Access Compliance Report

Public Rights-of-Way

(Curb Ramps)

Intersection ID: 2745	Main Street: HIGHLAND_CREEK_PY	Cross Street: SHELLEY_AV	Location: W
ADA ID: CD6741306FF7	Ramp Type: Perp	Initial Pass/Fail: Pass	Overall Compliance: No
Severity Score: 5.25			
Codes/Mitigation Info/Possible Solution		Field Measurements/Component Compliance

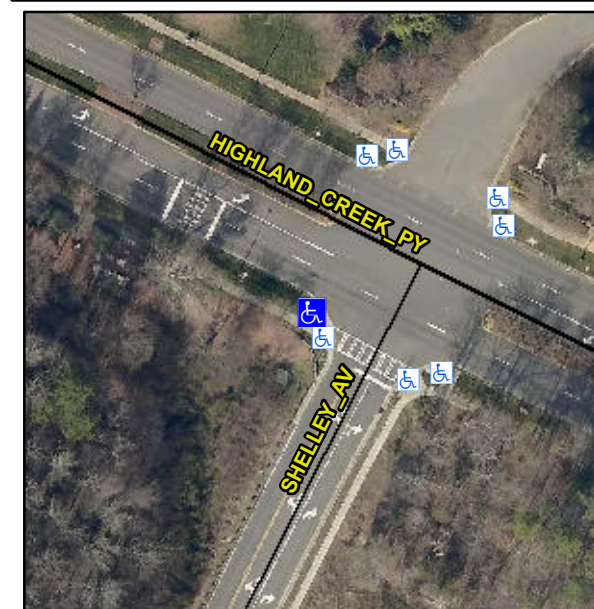
**Remove & Replace Entire Ramp.
Remove & Replace Gutter.**

R304.2.3, R305.2, R304.5.3
